ADDENDUM NO. 2

DATE OF ISSUANCE: March 21, 2023

PROJECT: 2023 Henryville Flooring Replacement
Phase 2 & Cafeteria Expansion
213 N. Ferguson. St.
Henryville, IN 47126

ARCHITECT'S PROJECT NO.: 21-47.007

SHEET NUMBER
S301
202147.007

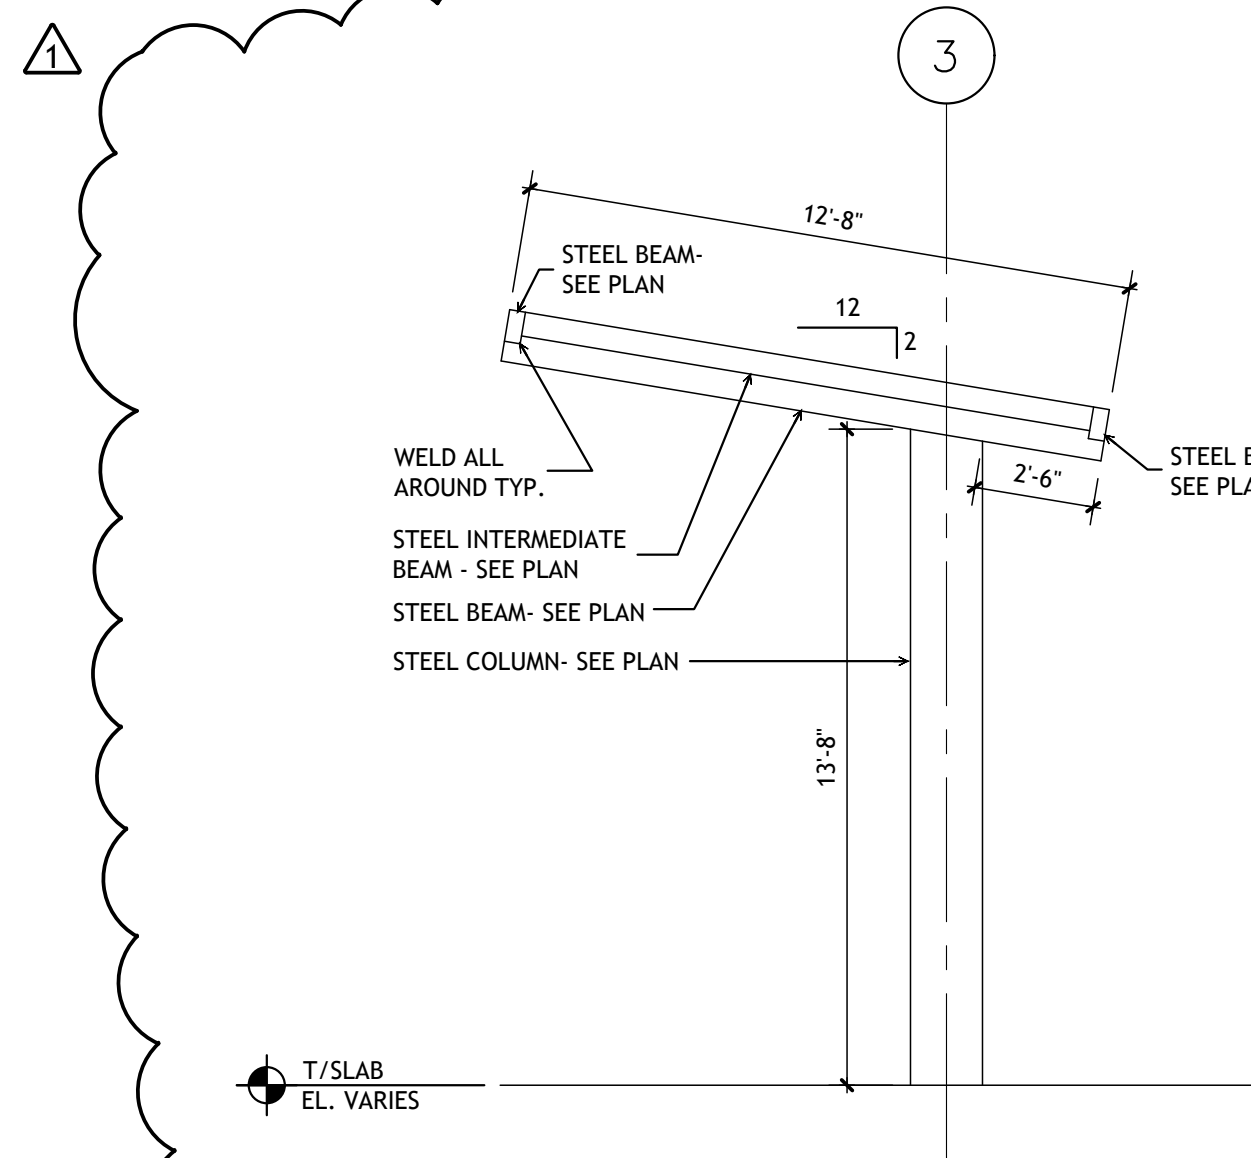
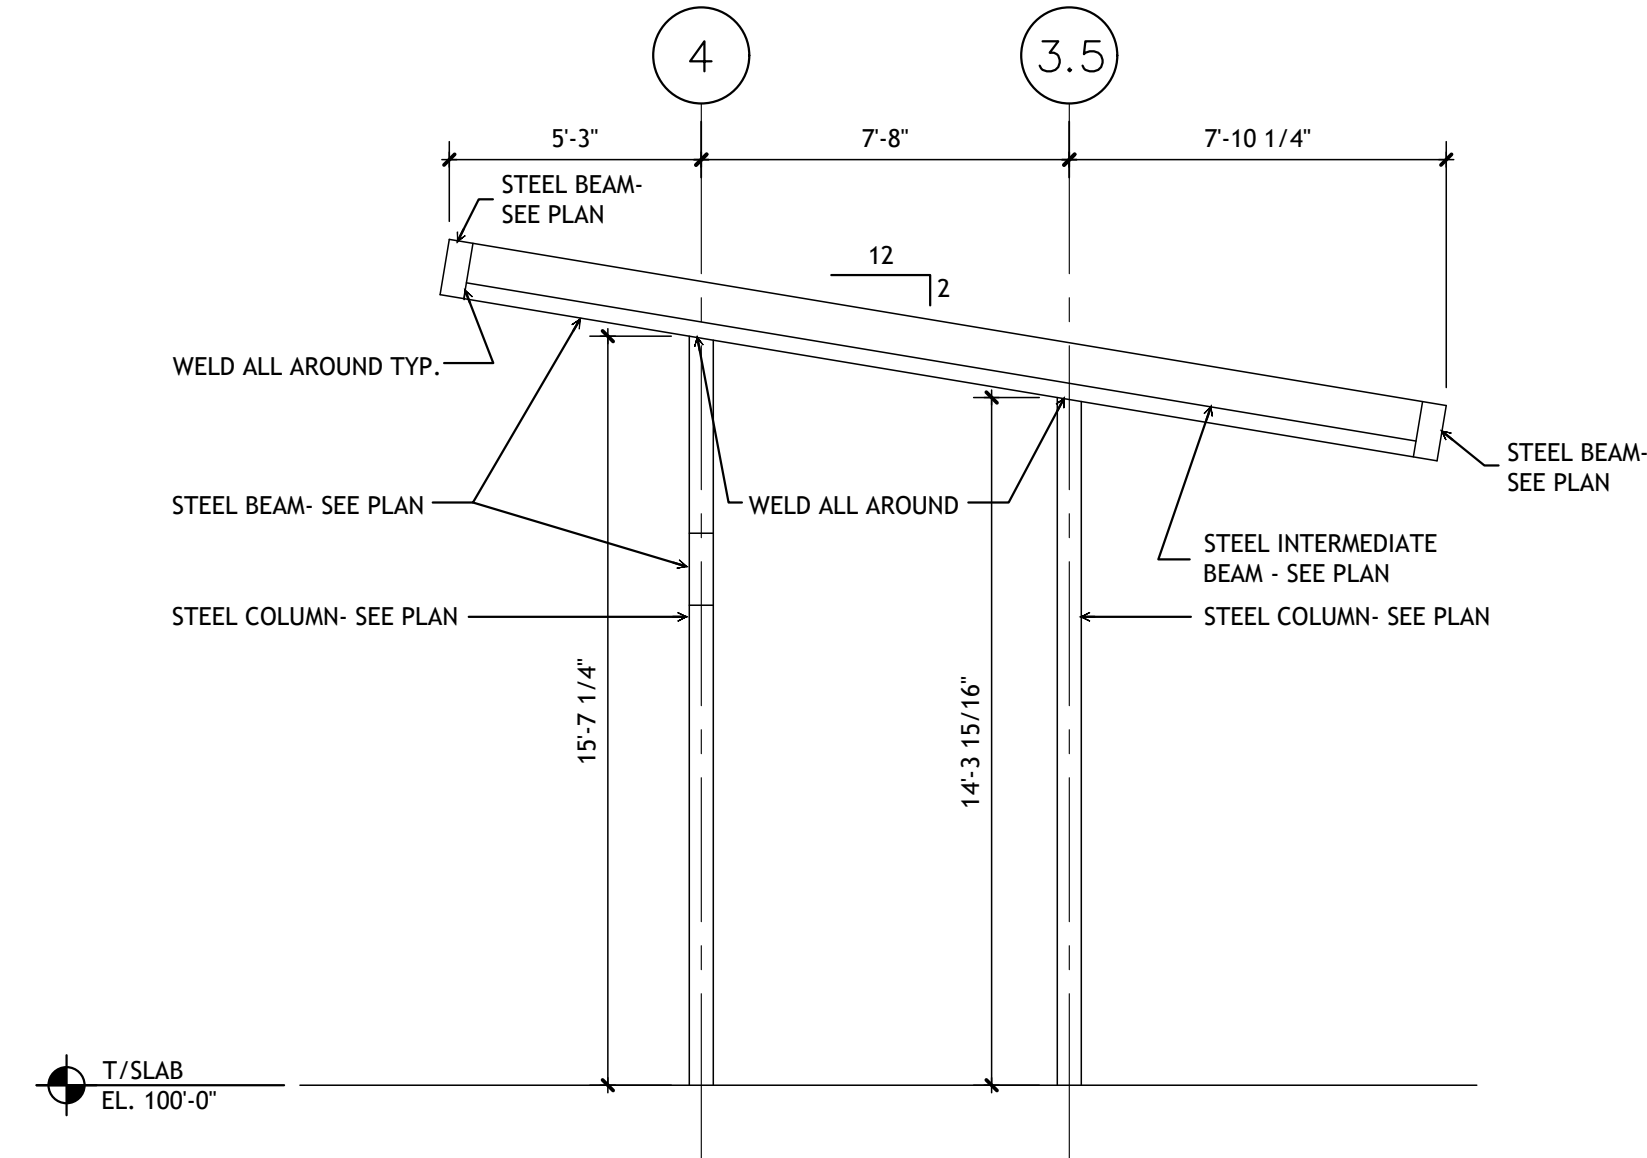
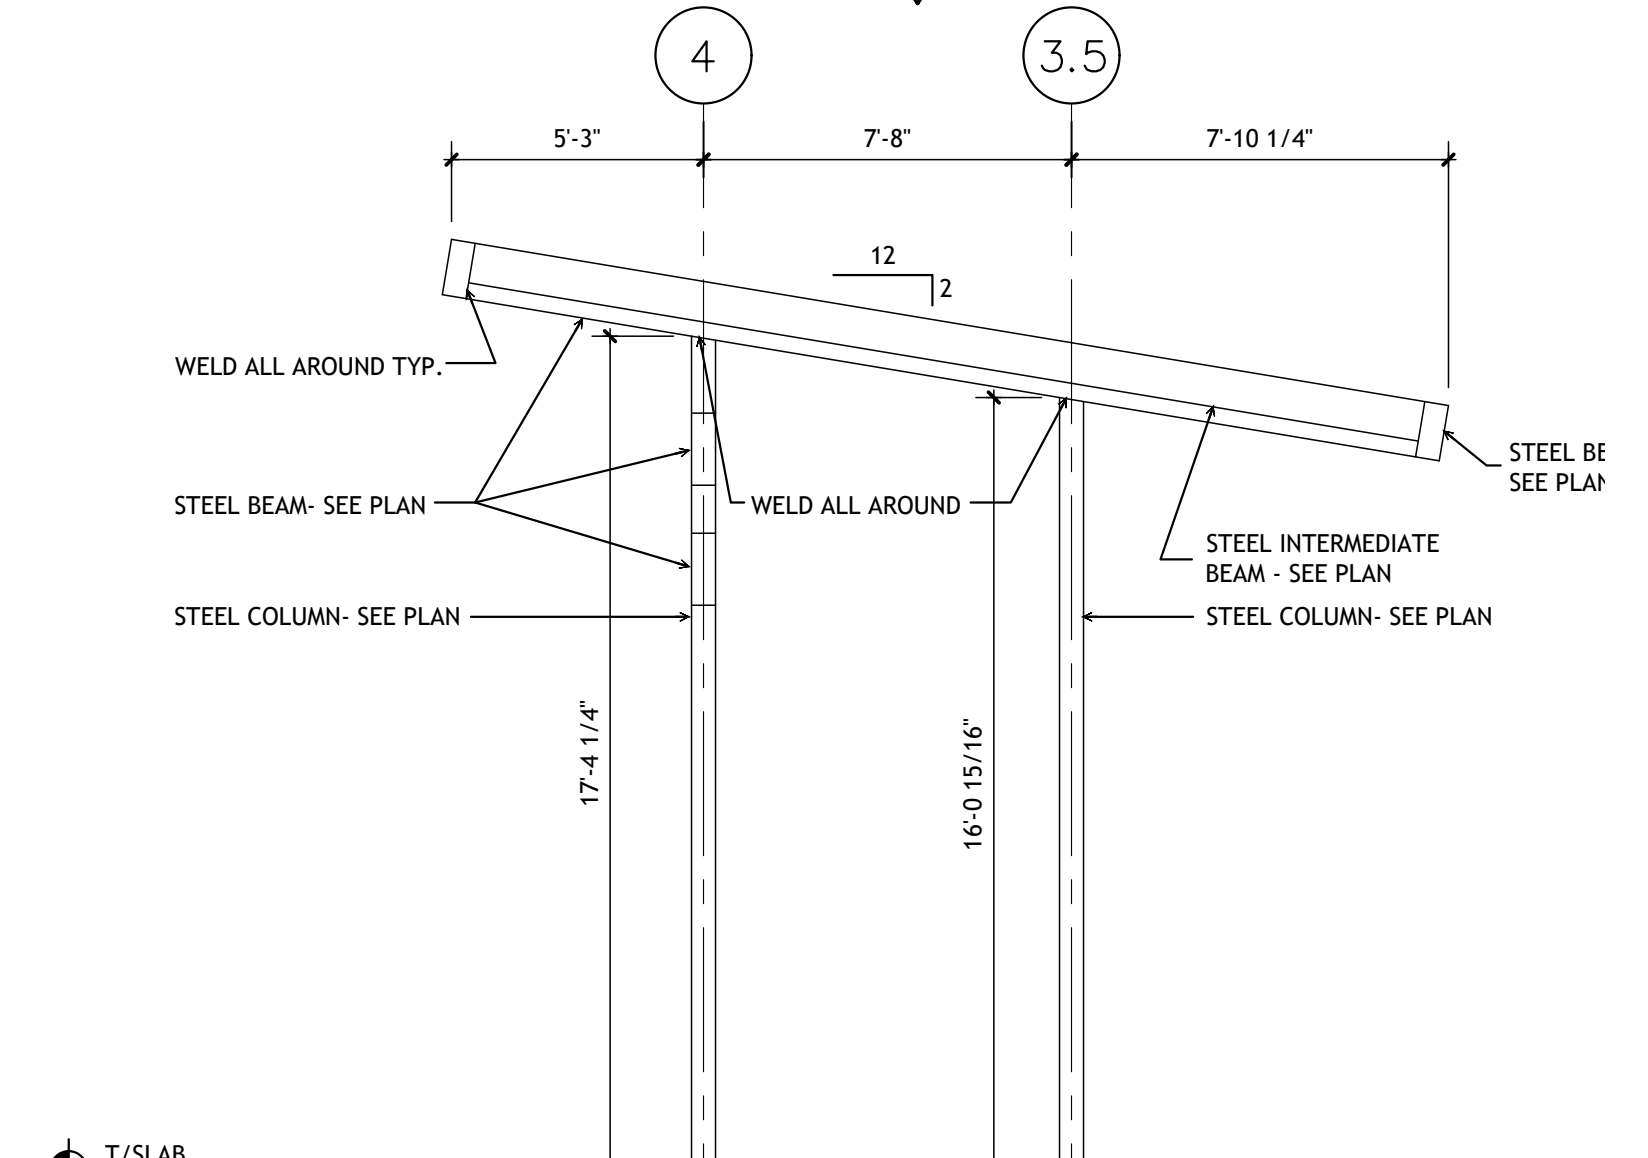
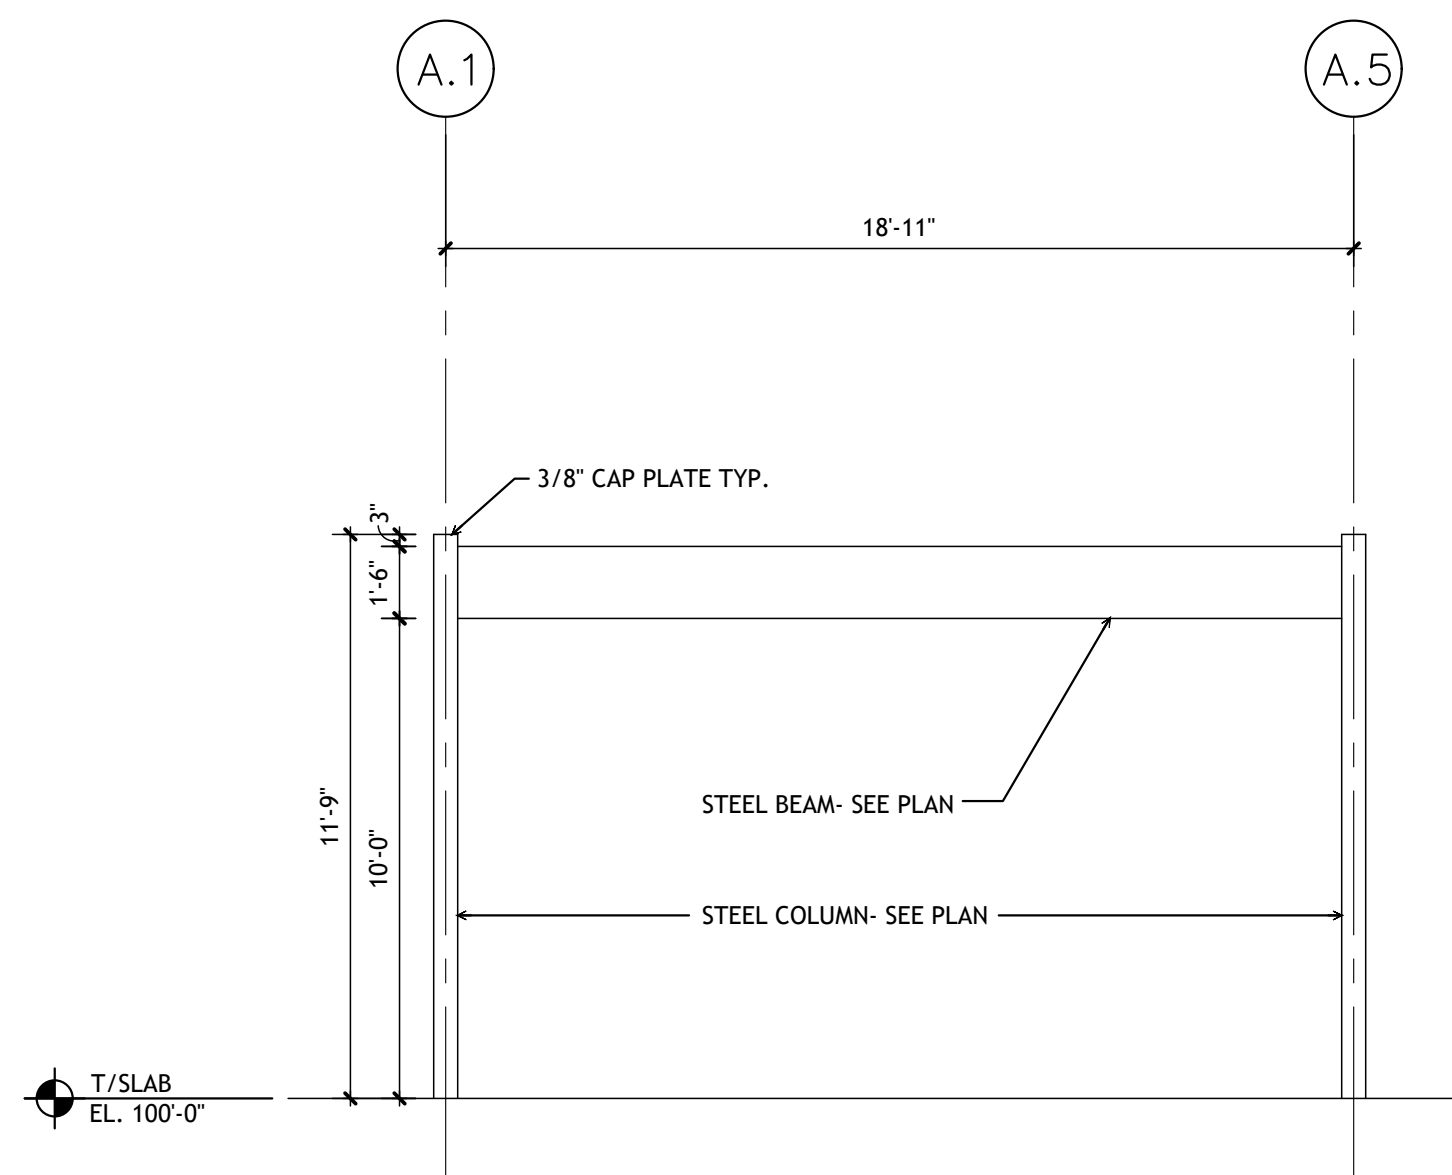
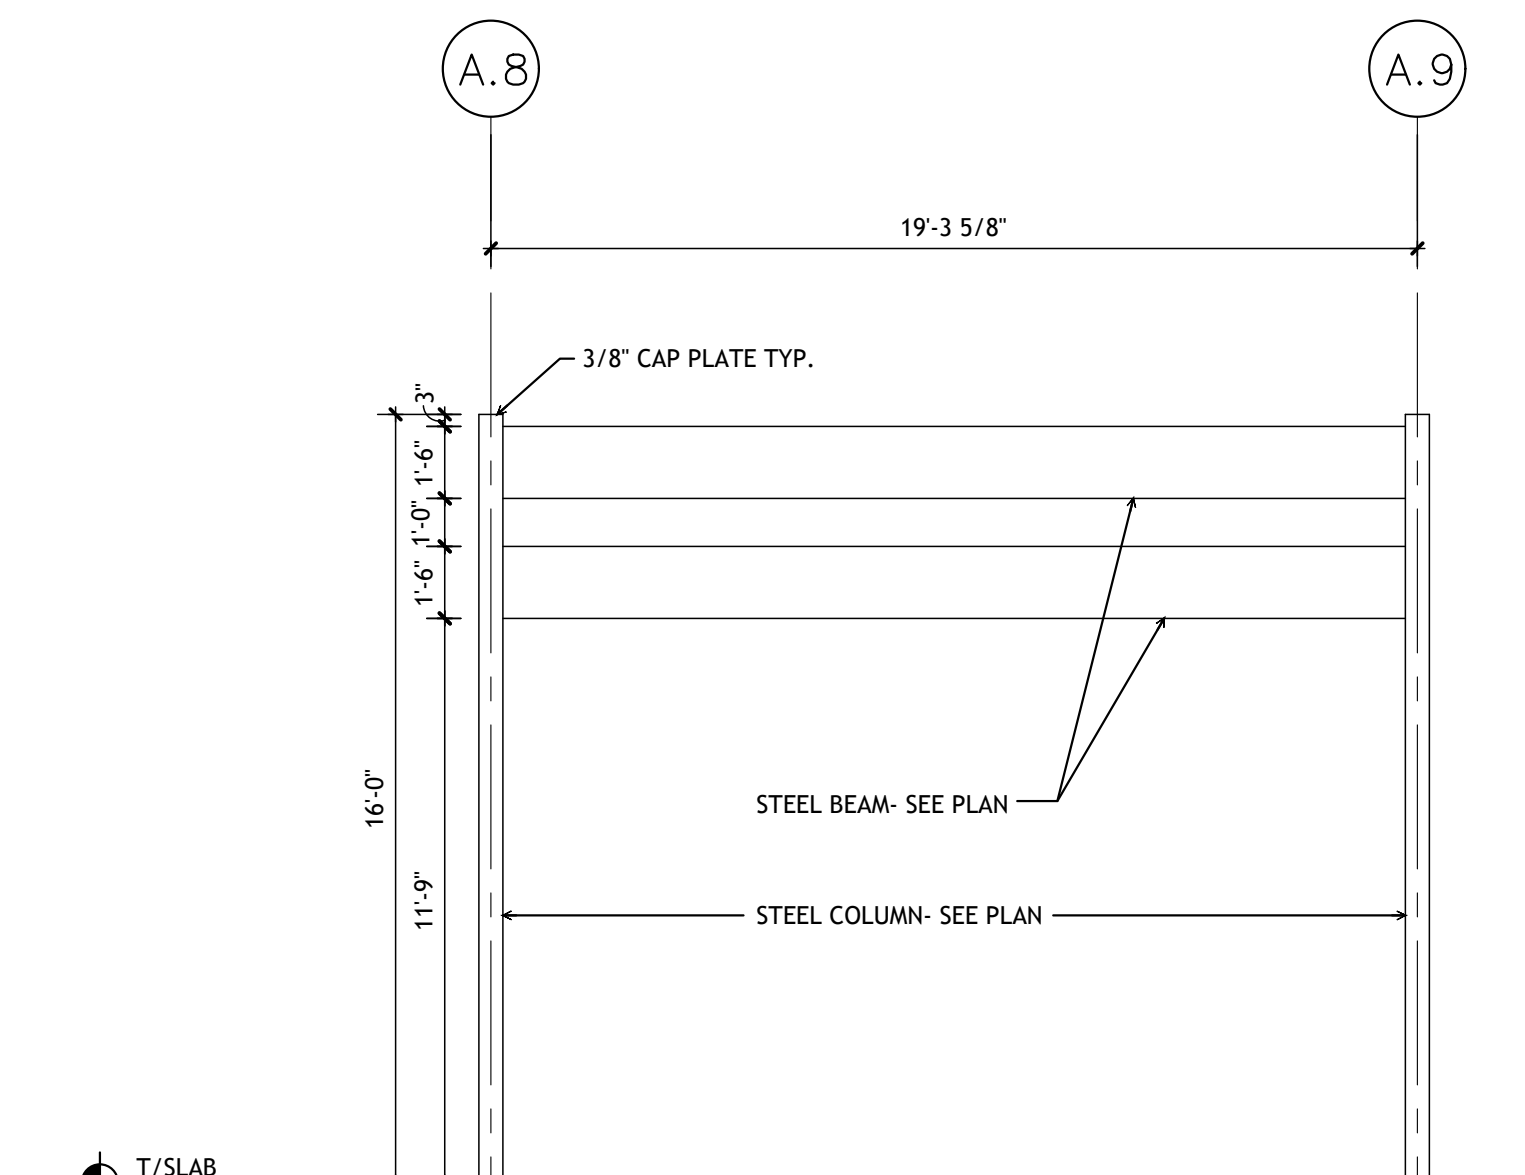
ADD-1 Item No. D-6 - Framing Details

Refer to Sheet(s): S301

Replace with attached revised Drawing in its entirety; revisions have been clouded for reference. Frame profiles have been added for Alternates 2A & 2B.
